Historic Architectural Review Commission

Agenda Packet

Item 5.b.5.

CL5 - Request to install aluminum sliders and minor repairs - #915 Cornish Lane - Robert L. Delaune, Architect (H09-12-28-1439) - Remove existing wood doors and windows where indicated (five openings) and install new aluminum sliders (impact). Replace wood decking and modify pool edge. Rebuild entry stairs.

SITE & FLOOR PLANS
 scale: 1/4"=1'-0"

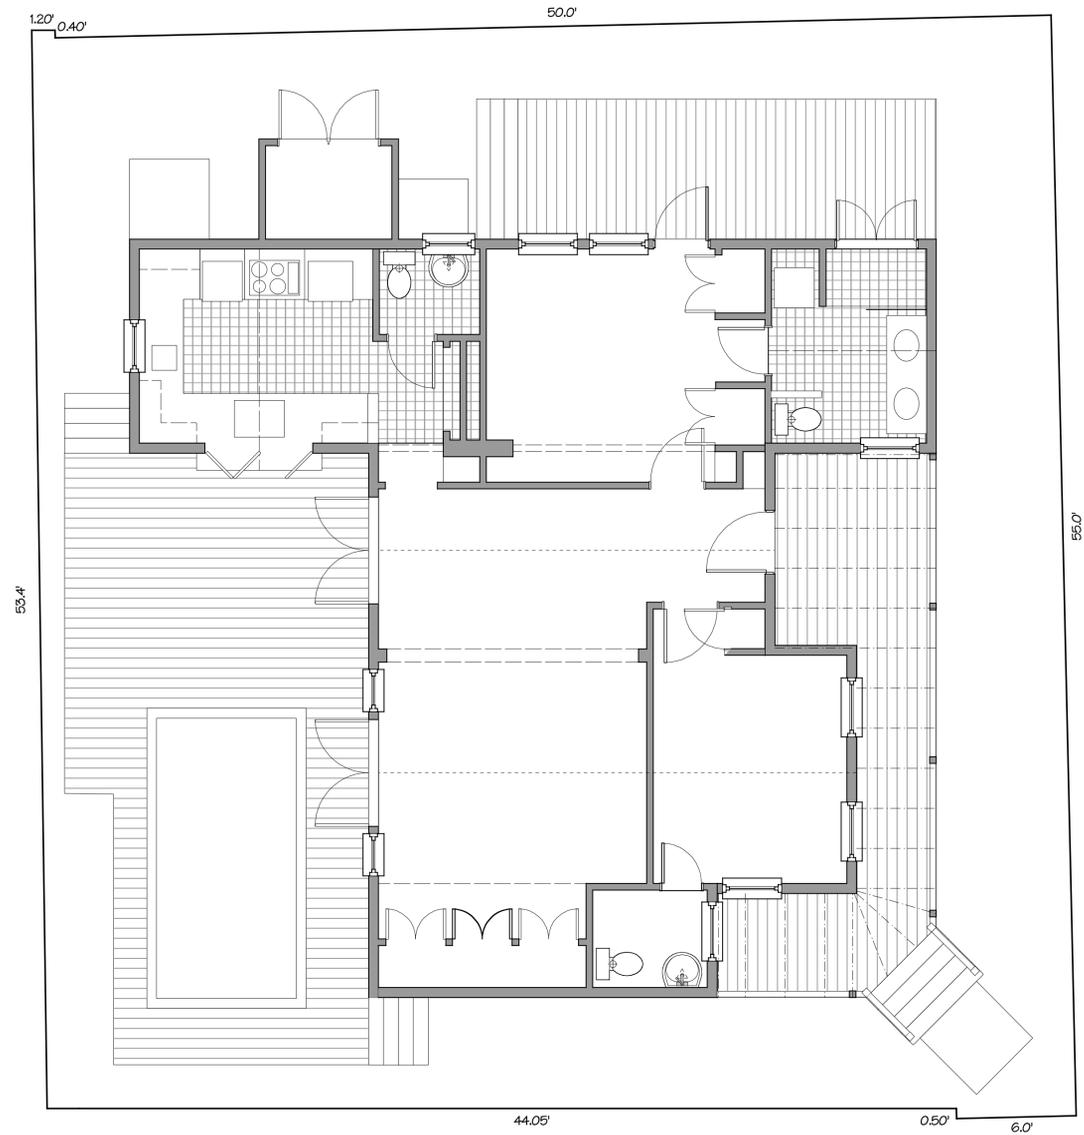
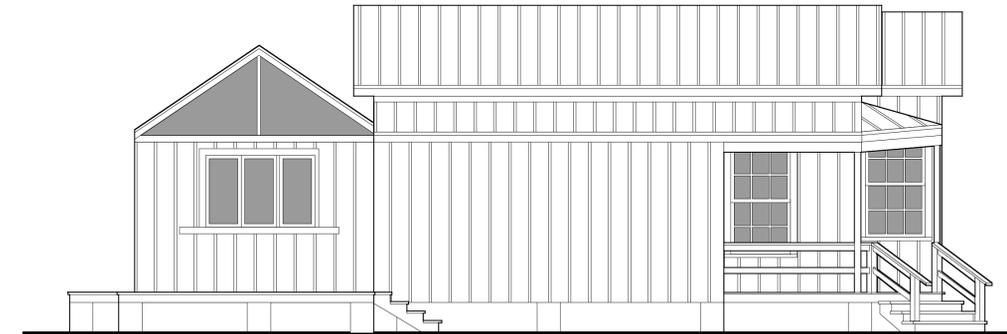
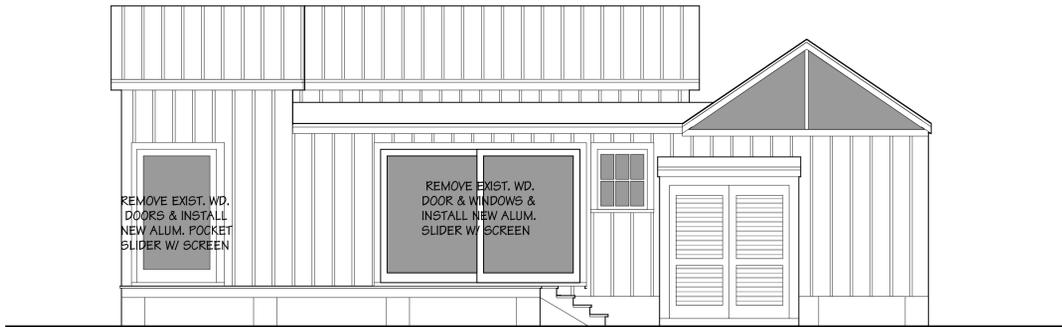
The only elevation that is original to the historic fabric that will have new aluminum pocket sliders will be the north one. Infill for the transom windows that will be removed will match the existing board and batten. The existing kitchen and all the north east corner of the house were added after 1962. A new aluminum pocket slider is proposed for the south elevation of the kitchen. Also on the north elevation of the existing bedroom and master bathroom aluminum pocket sliders are proposed.

The plans proposes the removal of existing non original wood French doors and windows. The proposed change will be on facades that are not visible from the right-of-way.

Staff understands that the intention of the guidelines regarding windows and doors in the historic zoning districts is that the use of wood on these architectural elements is most appropriate on historic buildings. Wood is the traditional material used in the historic fabric and is the most appropriate material to use on the contributing portion of the house.

Staff recommends to this honorable commission to **approve** the proposed improvements **with the condition that the pocket sliders, at least on the north elevation, are made of wood.** Staff understands that the proposed new deck and repairs of front steps are in keeping with the Historic Architectural Guidelines.
